The Narragansett Electric Company
d/b/a Rhode Island Energy

**Proposed FY 2024 Electric
Infrastructure, Safety, and
Reliability Plan**

**Responses to Division
Data Requests – Set 1**

Docket No. 22-53-EL

Figure 2 – 34F1 TCC

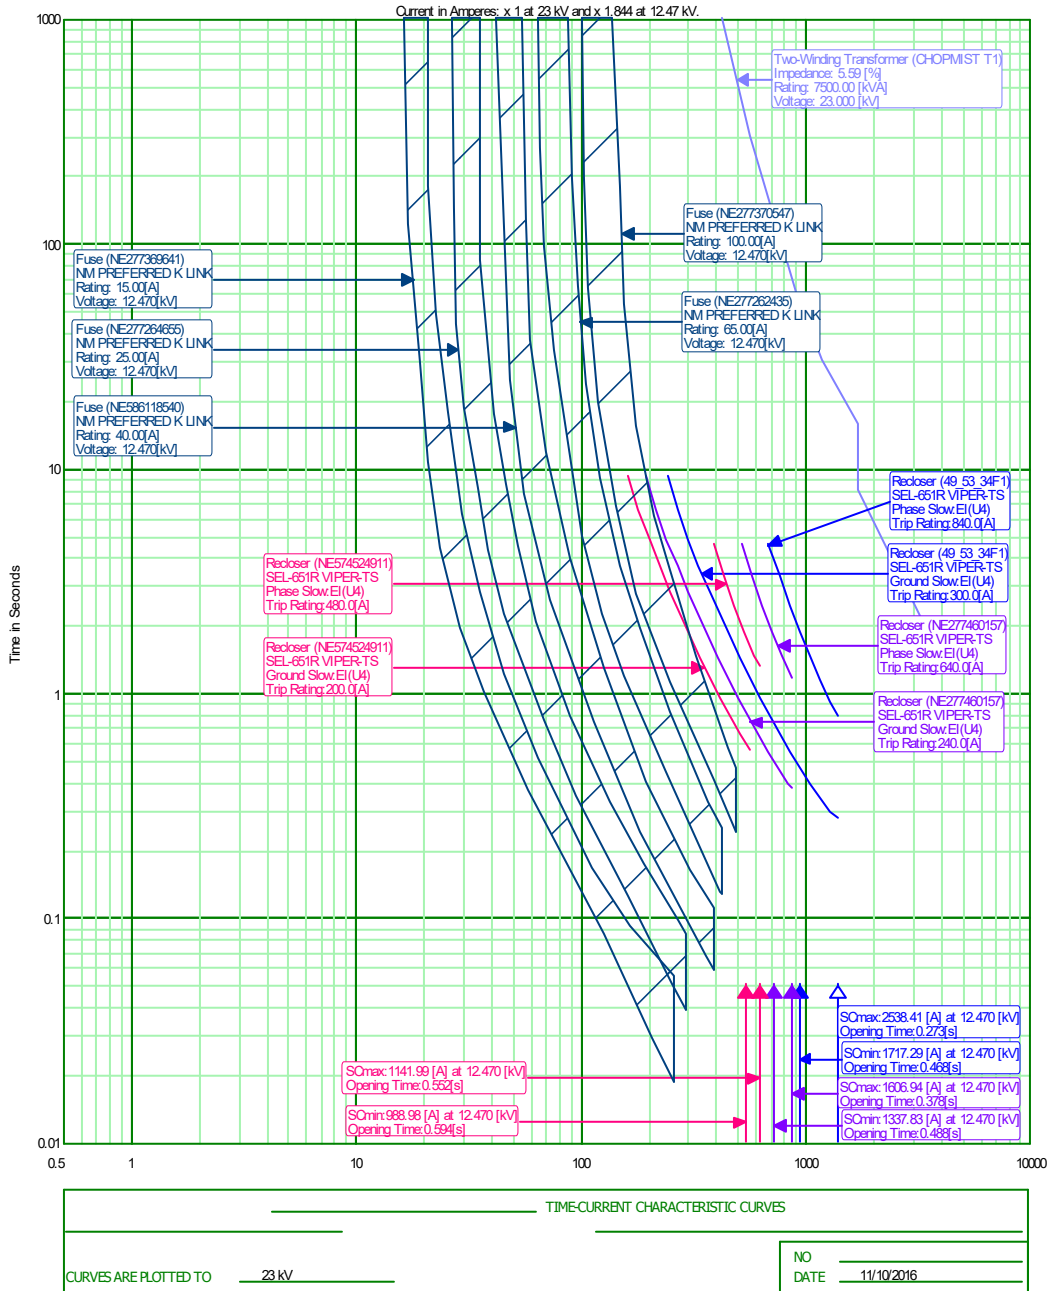
Division 1-27

Figure 3 – 18F5 TCC

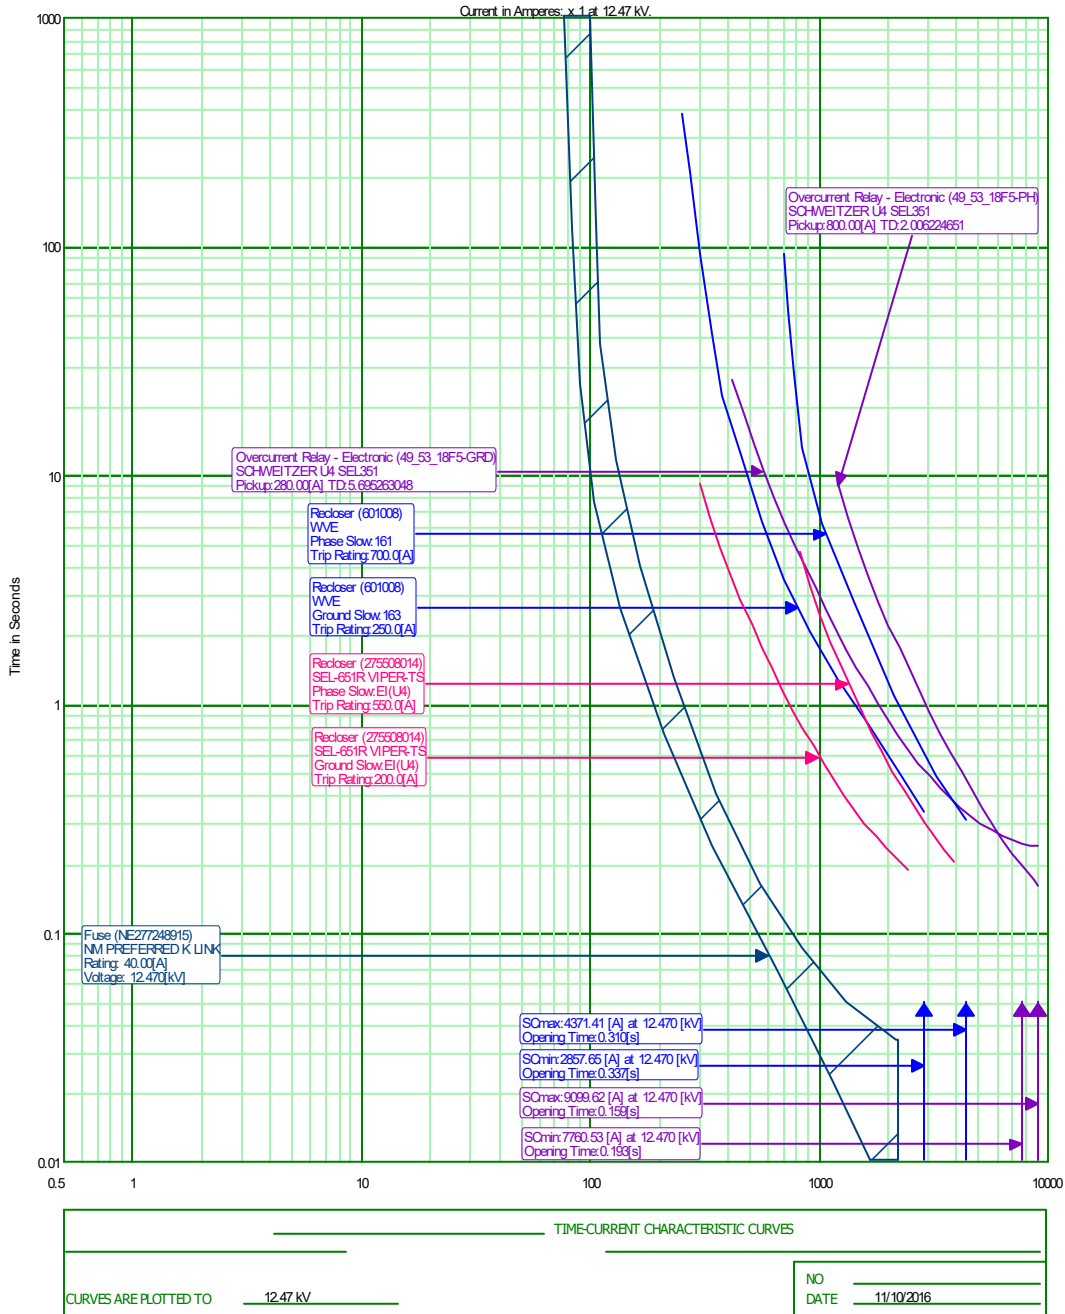
Individual feeder maps showing the existing and proposed protective device changes are not available. Although various programs and systems, such as CYME and EMS, can create maps with protective devices, the Company does not produce such maps to perform protective coordination and device placement. Instead, the programs are used directly. Also, device placement is still being determined. An example CYME diagram, shown in Figure 1, below, is provided for the 18F5 feeder out of the Johnston substation. The response to DIV 1-27 shows the time current coordination curve for this circuit with the new recloser.
